515 W. Broadway Mixed-Use Project

Final
Environmental Impact Report

515 West Broadway Mixed-Use Project

(SCH No. 2014071092)

Mezzanine Level Parking Floor Plan

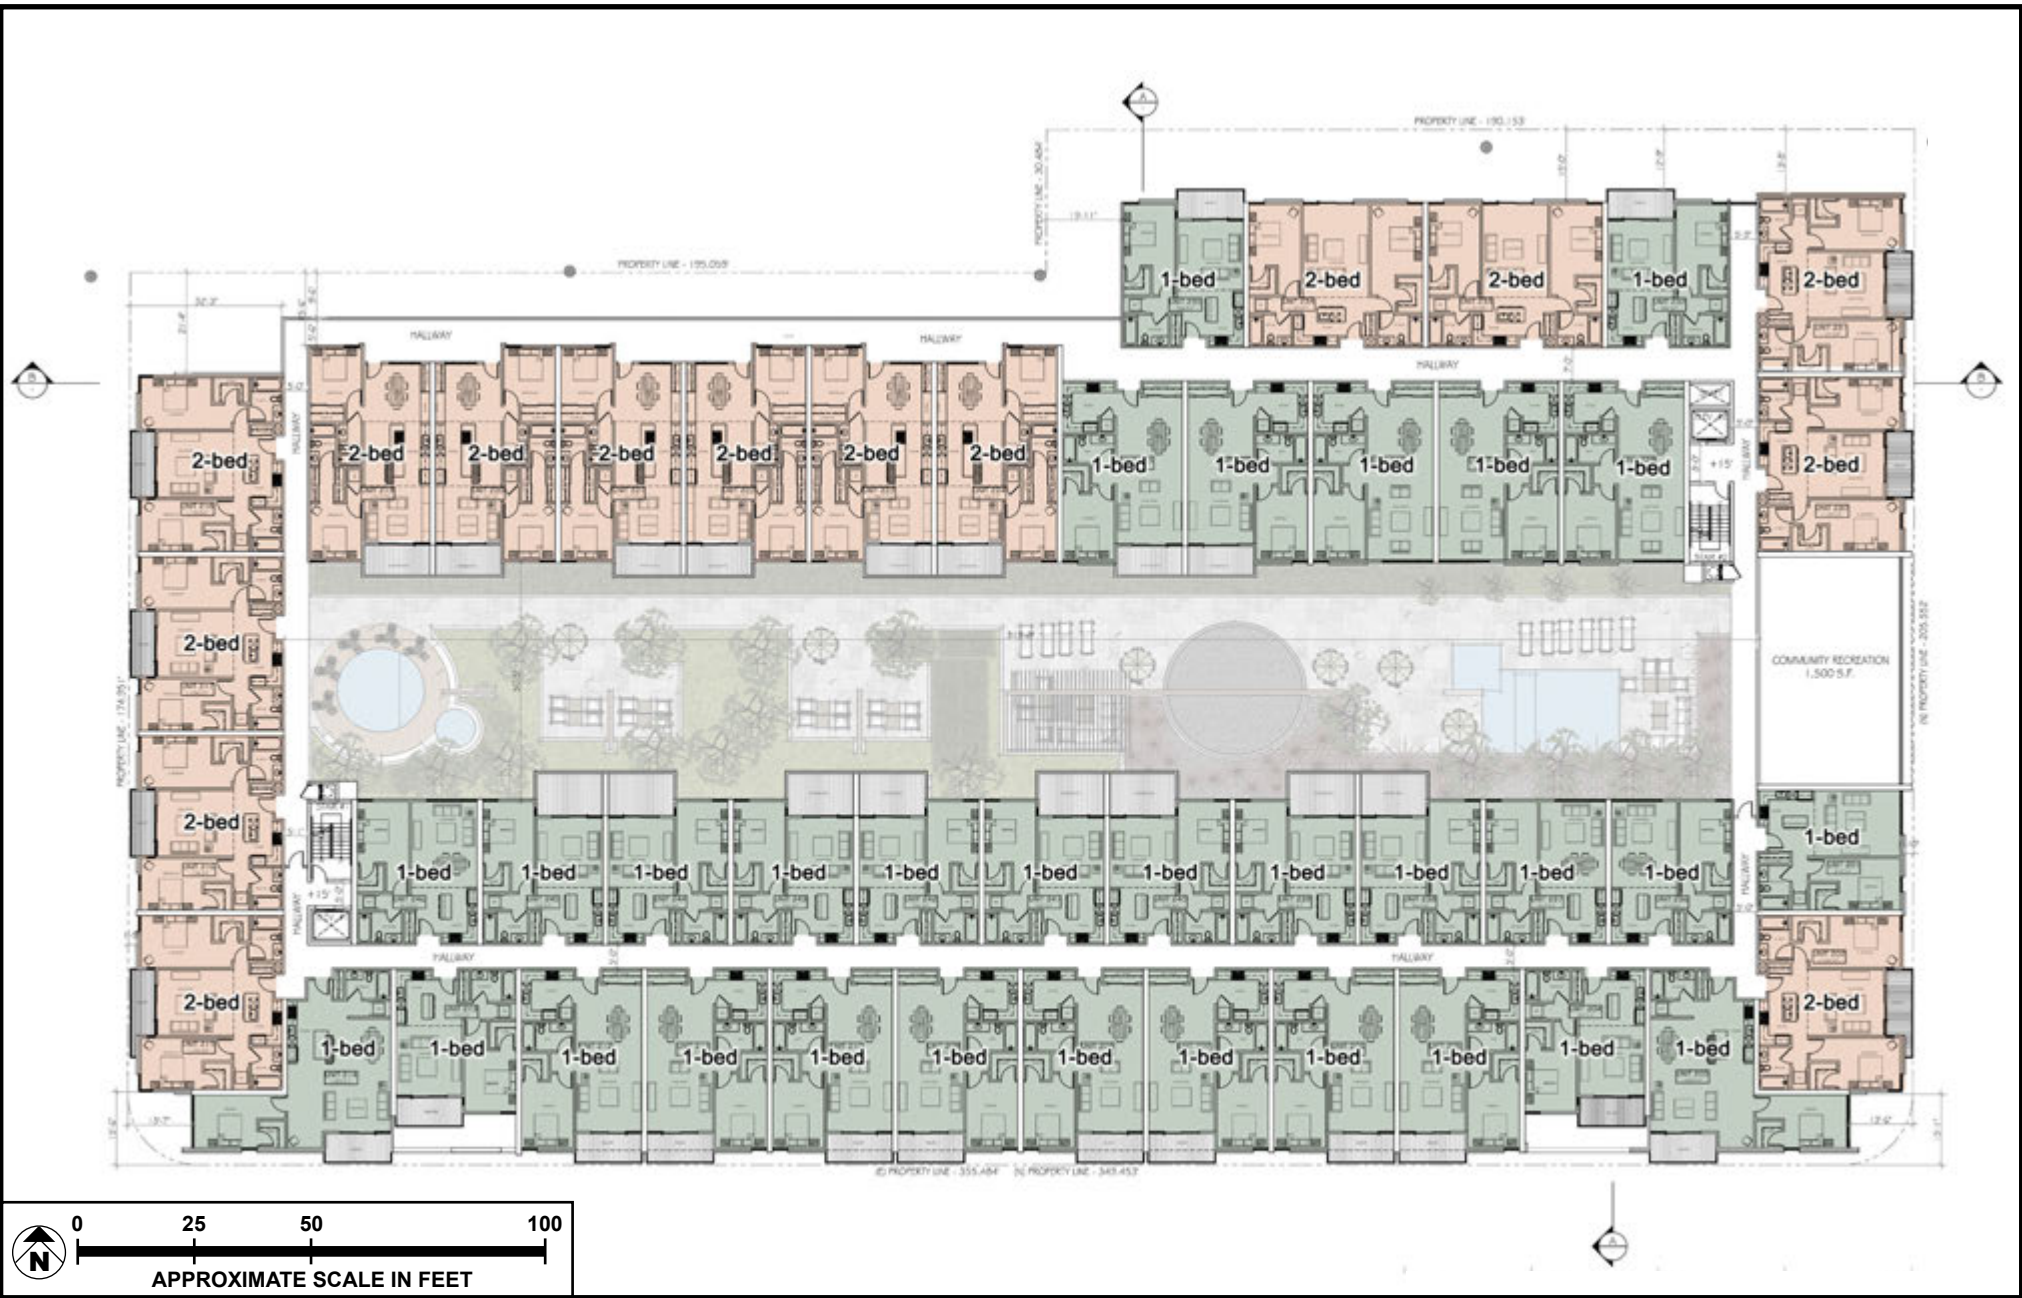
The comment indicates the Project will offer inadequate on-site parking with 212 spaces for 180 units. Of the 212 parking spaces, 40 are tandem. The comment further states that this amount of parking is equivalent to approximately one space per apartment, and the projected rent for these apartments would require two working people with two cars to afford the rent. The comment also recommends the Project include a minimum of 300–360 parking spaces in addition to 20 guest parking spaces.

Response. The Draft EIR discussed that parking would include a total of 331 parking spaces, including 212 subterranean-level parking spaces and 119 street-level parking spaces. The plans for the Project were revised to add 72 mezzanine-level parking spaces, to increase subterranean-level parking spaces from 212 to 221, and to decrease street-level parking spaces from 119 to 101. As revised, the Project would provide a total of 394 parking spaces and not 212 spaces as indicated in this comment. Of the 394 parking spaces, 221 parking spaces would be located in the subterranean parking garage and reserved exclusively for residents. Of the 394 parking spaces provided, 152 (76 pairs) are tandem, with each set of tandem spaces assigned to a single residential unit. Additionally, the Project includes 101 additional parking spaces to accommodate the proposed commercial use.

The following revisions have been made to address revisions to the plans for the Project. Mezzanine-level parking was added to the Project. This change has not increased the height of the building. Parking plans are illustrated in revised **Figures 3.0-3, 3.0-4, and 3.0-5**. Updated figures have been included at the end of this section.
